STAFF REPORT

AGENDA ITEM (File No. 14024)

Consideration of a Site Plan and Architectural Review application to expand the Fed Ex Ground distribution and delivery center located at 555 Federal Way in the Federal Way Business Park. The 8.27 acre site is zoned M-1, Light industrial and is identified by the Jackson County Assessor's Map as 37 2W 12B, Tax Lot 212. Applicant: Fed Ex Ground; Agent: Clark Stevens, Richard Stevens & Associates.

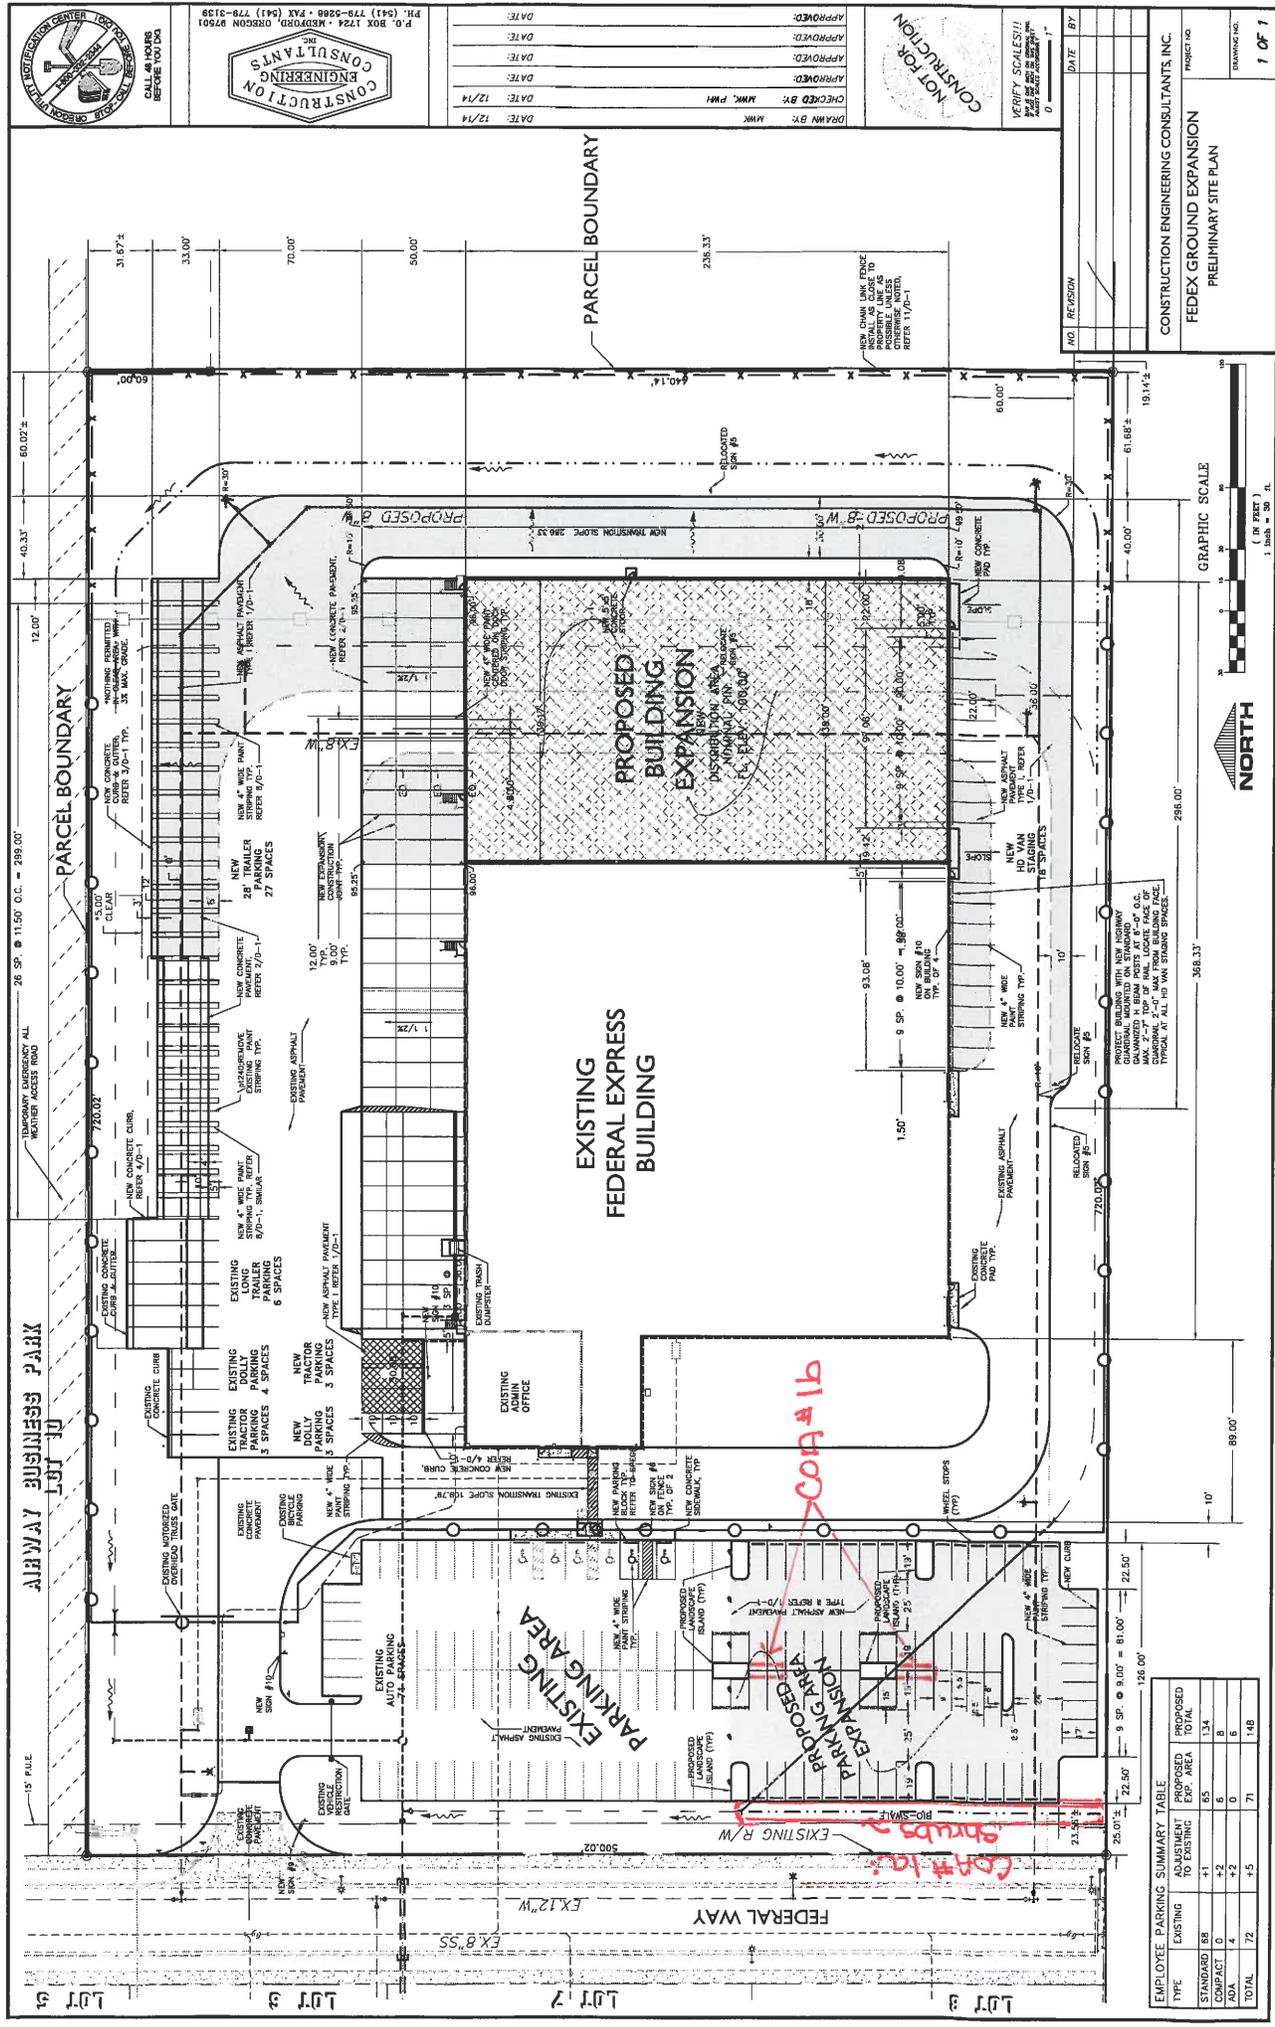
- a. Perimeter Landscaping Requirements. Perimeter landscaping for the proposed employee parking lot expansion consists of a 10-ft wide bioswale to the west and 5-ft planters to the south and east, which complies with the code's dimensional standards. However, shrubs are not included in the bioswale as required per Table 17.75.03. A condition has been added requiring the planting of shrubs in the bioswales per an approved stormwater management plan.

- b. Terminal and Interior Islands. The central parking rows in the proposed employee parking area expansion include two islands that are oriented perpendicular to the parking stalls. This layout is a typical, but was used in conjunction with compact spaces to avoid loss of parking. Typical island dimensions are 8-ft. by 38-ft., the proposed island dimensions are 8-ft by 28-ft which are substandard. The appropriate sized landscape islands can be easily provided without the loss of parking. A condition has been added requiring correction to the landscape islands.

1. Prior to building permit issuance, the applicant shall submit a revised landscape plan that includes revisions per Attachment "A-1" or as otherwise designed to provide the following:

- a. A minimum of 19 shrubs planted within the bioswale planter along the west perimeter parking area; and,
 - b. Expanded parking islands at least 38-feet in length by 8-feet in width.
